**RE: Presbyterian Hospital "Make-Ready" Site Improvements
100 Central SE
Grading and Drainage Plan
Engineer's Stamp Date: 9/18/19
Hydrology File: K15D005**

Re: Presbyterian Healthcare Services Site Improvements – Hydrology Resubmittal: Hydrology File:
K15D005

PRESBYTERIAN HOSPITAL
SITE IMPROVEMENTS
1100 Central Avenue SE
Albuquerque, NM 87106

EXISTING
DRAINAGE
MANAGEMENT
PLAN

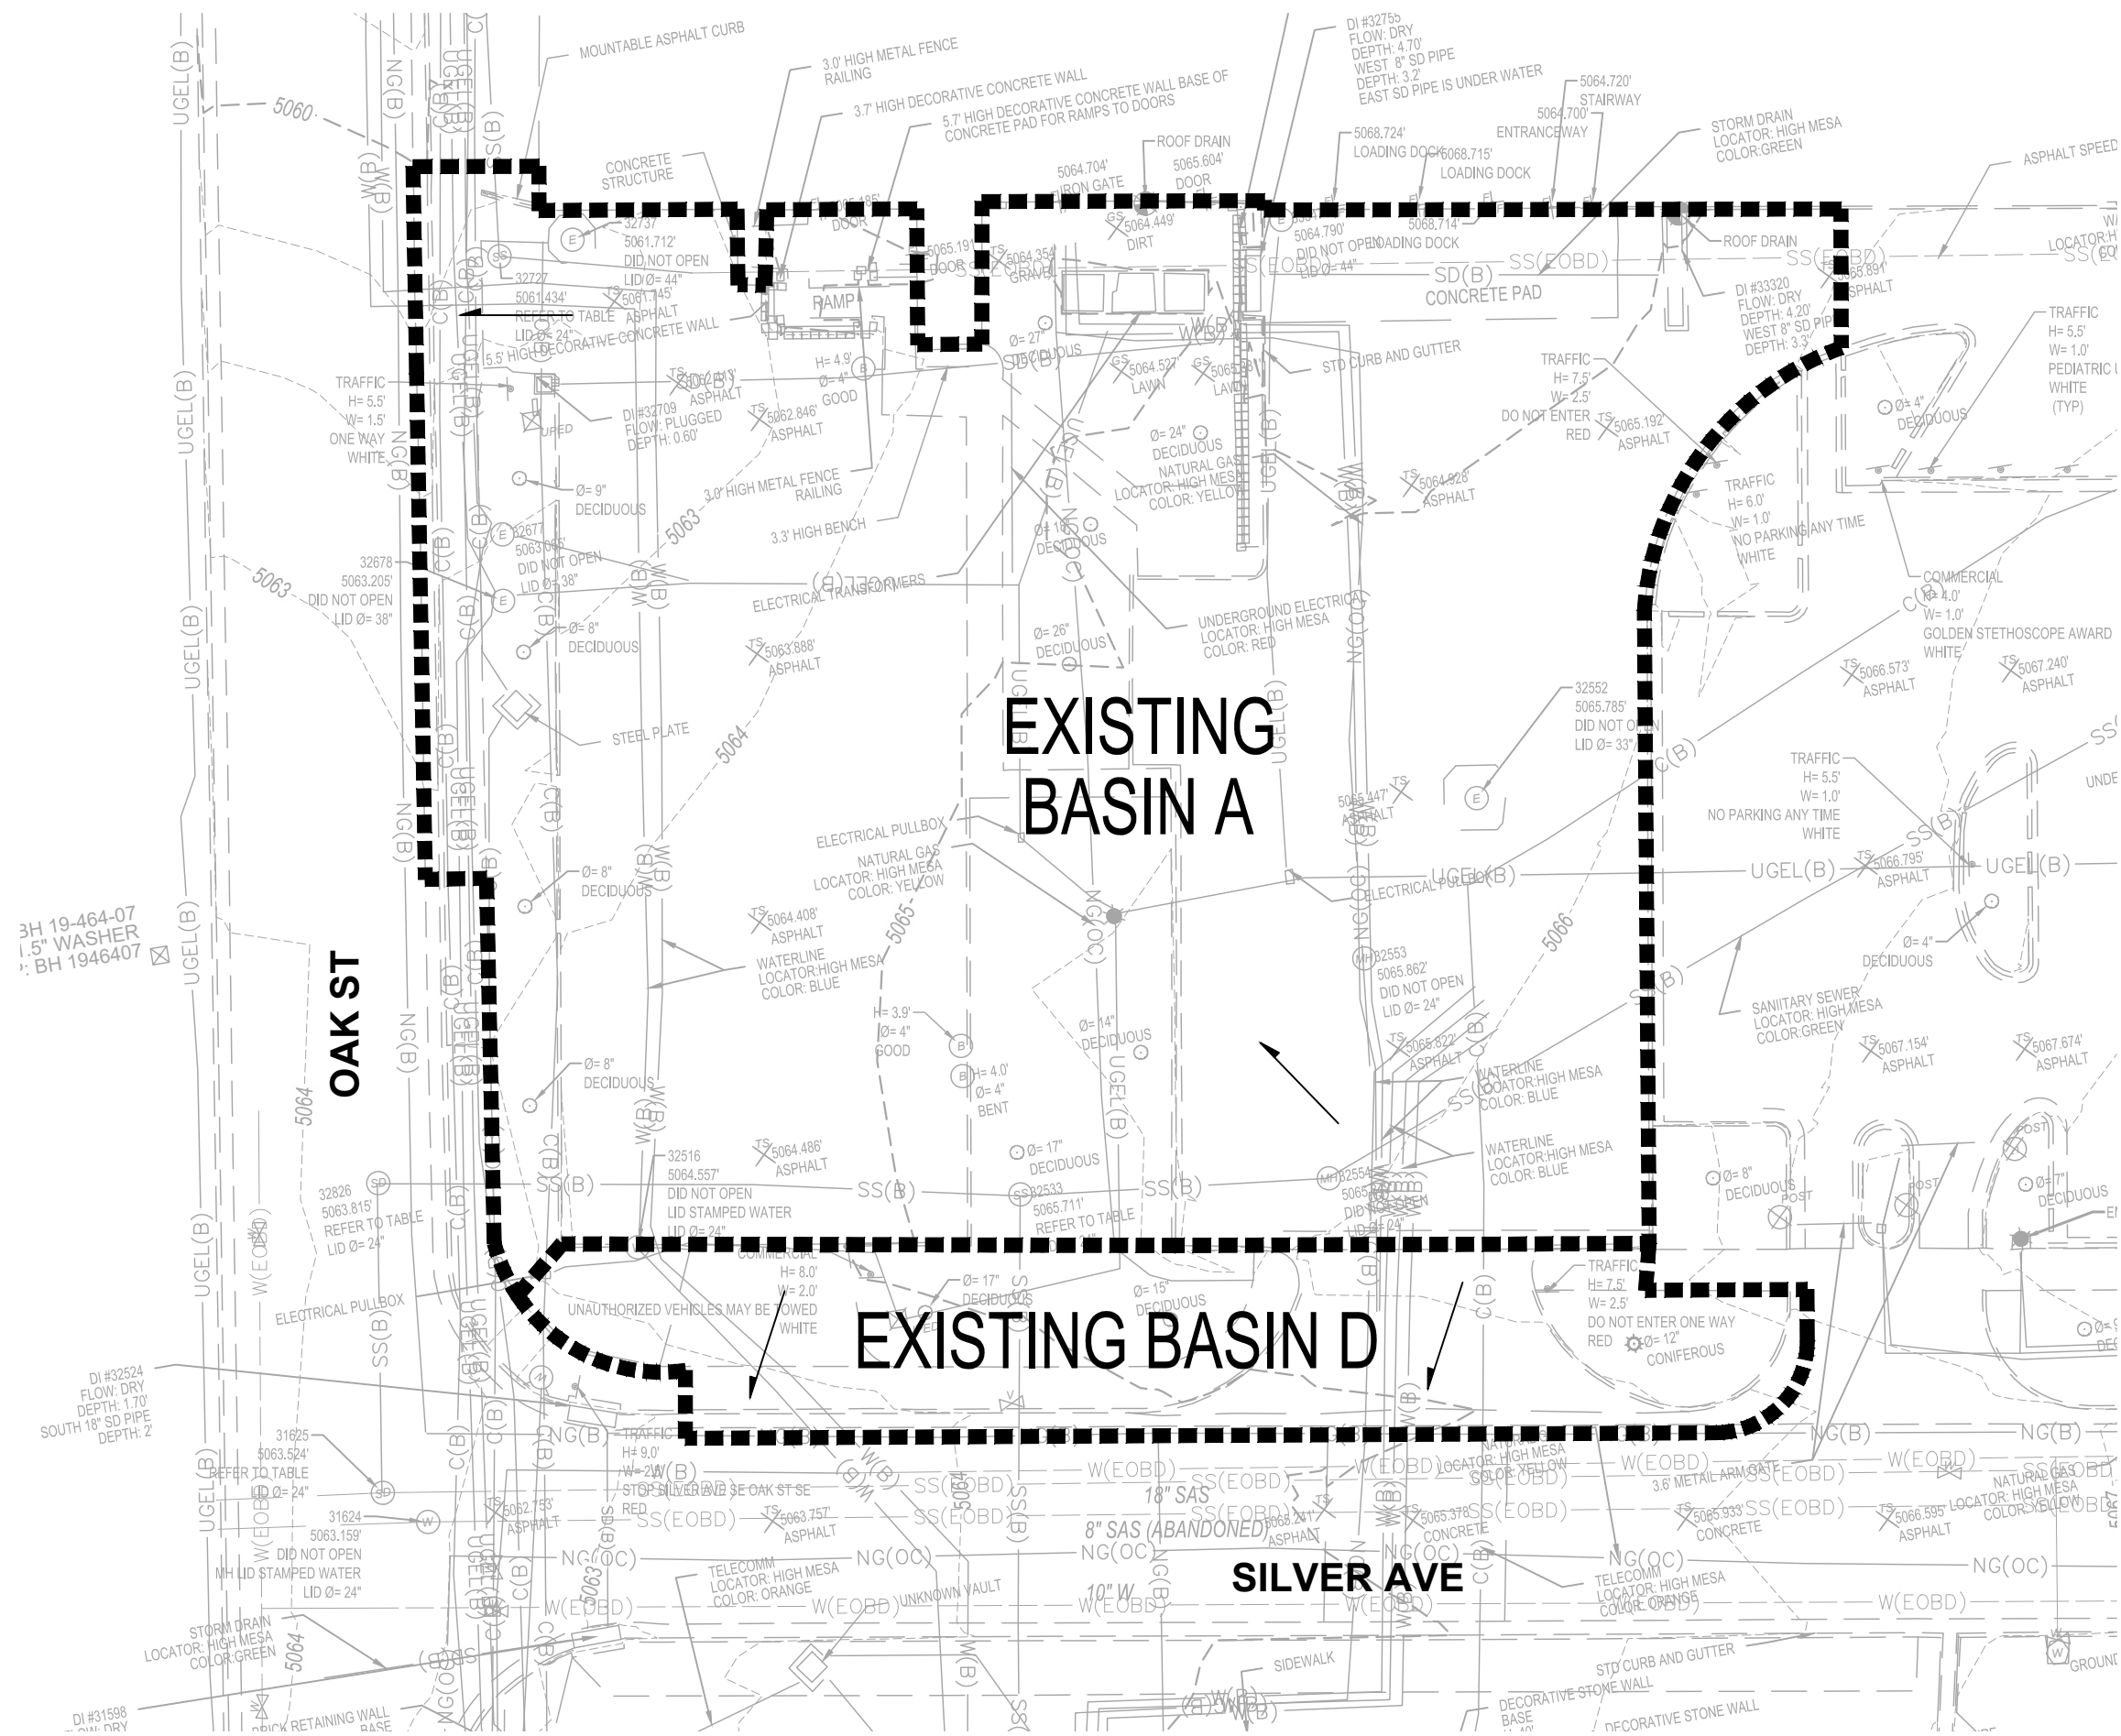
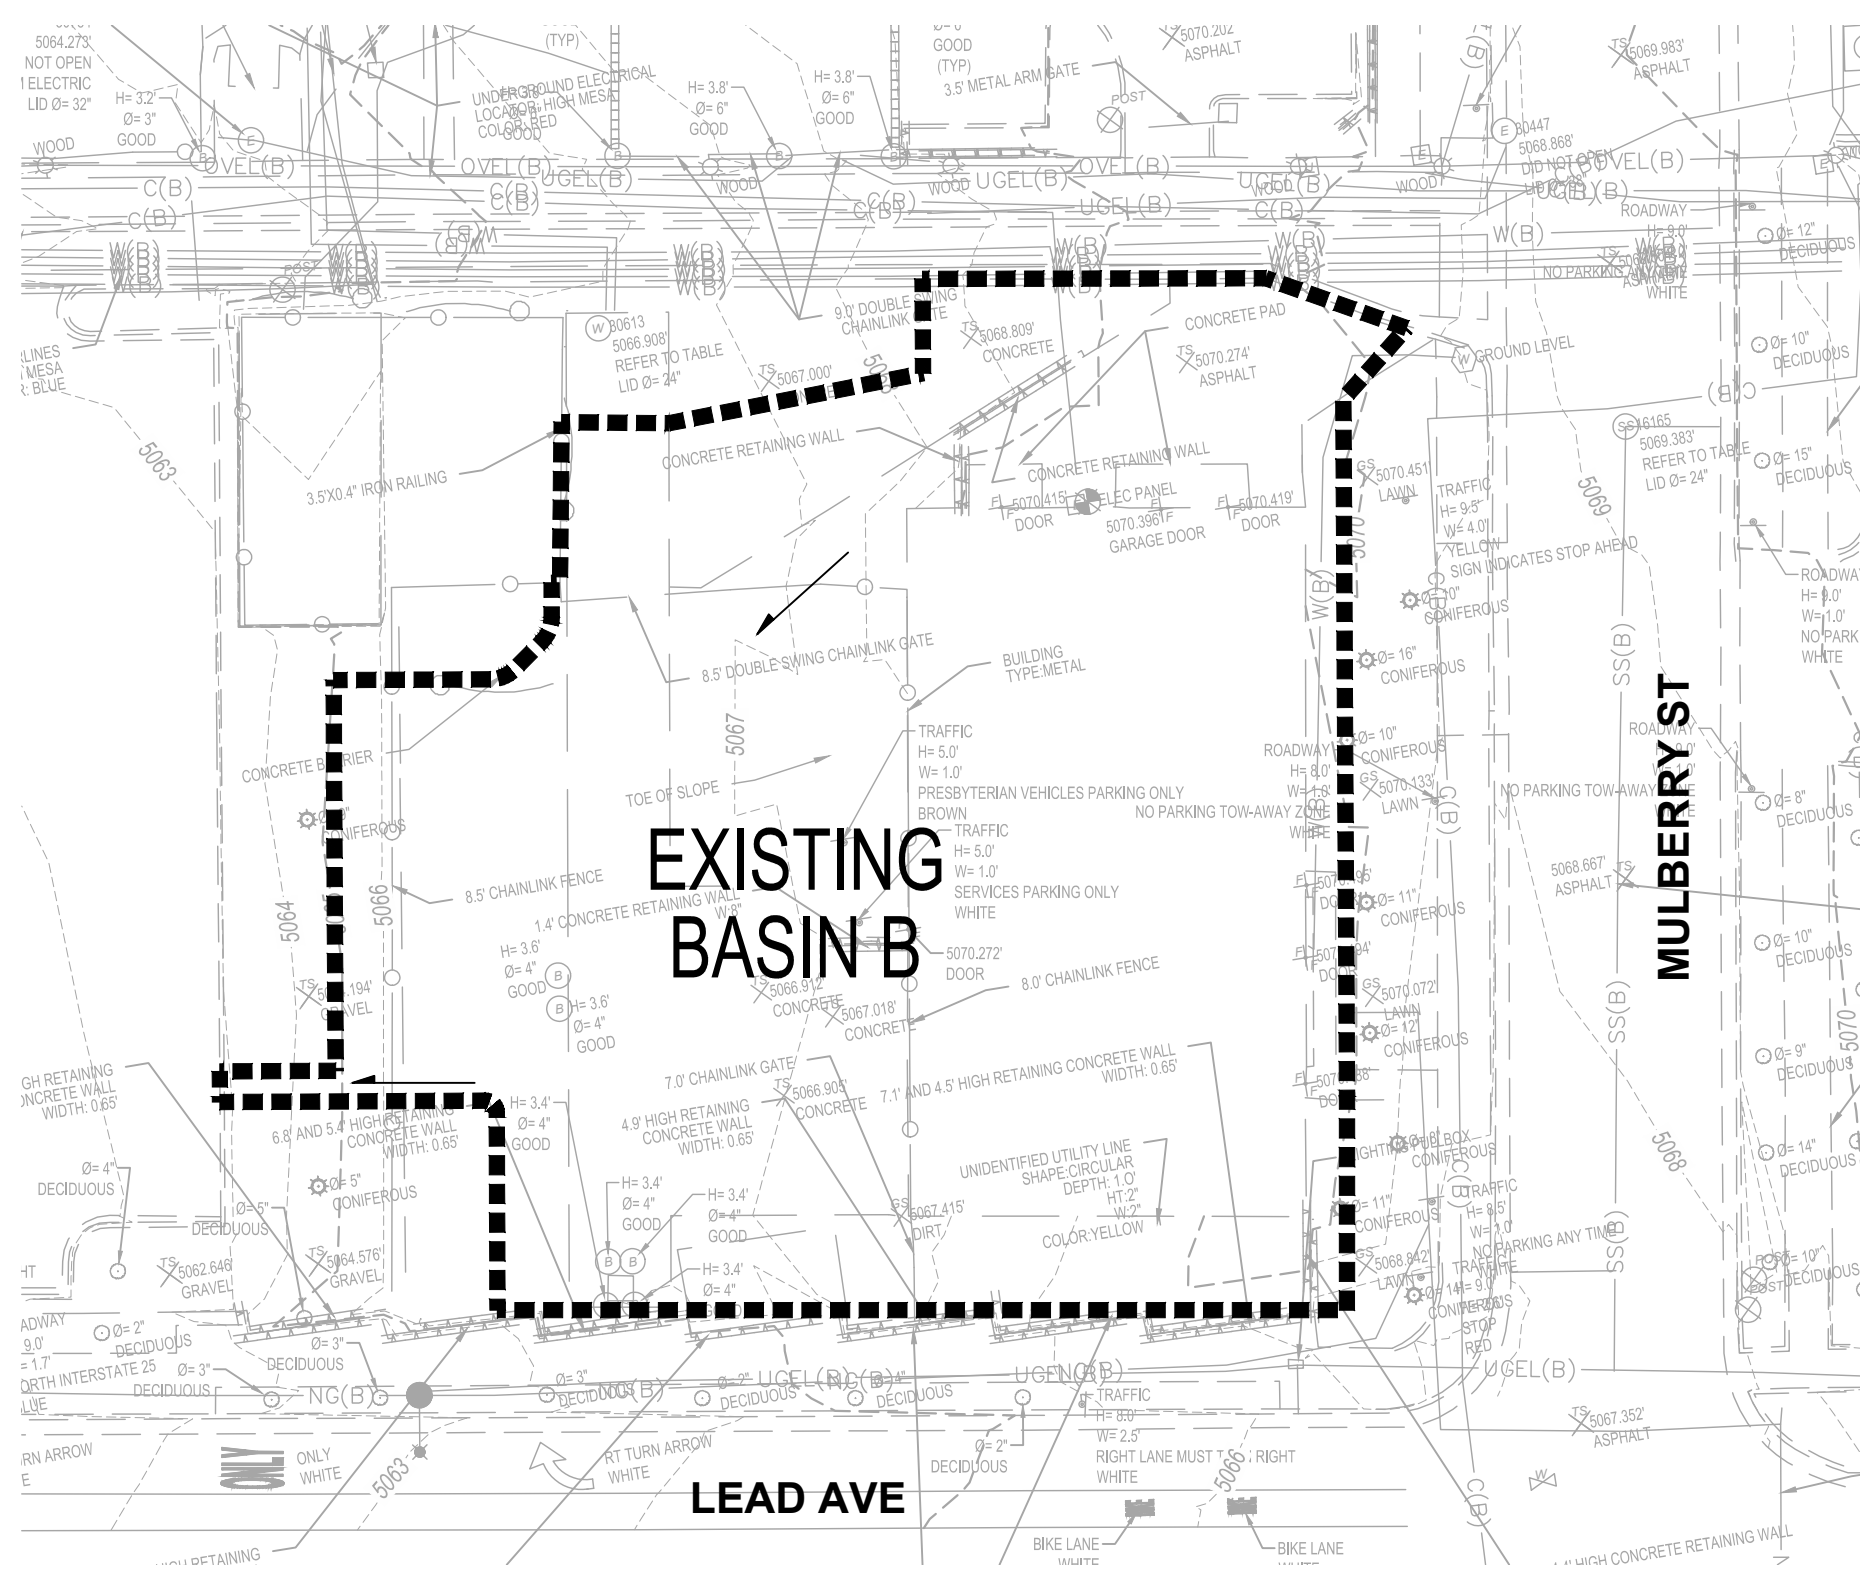
3. Each portion of the project (viewport) needs to include the street names.

4. Screenback or turn-off the extraneous survey layers.

6. Provide management onsite for for the Stormwater Quality Volume (SWQV) in accordance with the new drainage ordinance, § 14-5-2-6 (H) enacted 10/2/18 (Council Bill C/S O-18-2). You may elect to make Payment-in-Lieu for the onsite management for the volume not captured. In order to pursue this, the plan must state that: you could provide onsite management, you do not want to (due to cost or convenience), and you are electing to make the Payment-in-Lieu of onsite management.

7. This site qualifies as redevelopment and is only required to retain runoff from the 80th percentile storm (Vol.=0.26*Imp. Area).

10. Hydraulic calculations per the DPM Ch.22.3 are required for all sidewalk culverts, swales, storm drain, etc..

Response: This information has been added.

Response: The background information has been cleaned up to make the drawing more legible.

Response: Due to site constraints onsite management will not be provided and the owner has

elected to make Payment-in-Lieu of onsite management. This has been noted on the drainage management plan.

Response: Noted. The onsite drainage management volumes have been calculated based on the method noted in your comment.

Response: Calculations have been added to the Proposed DMP.
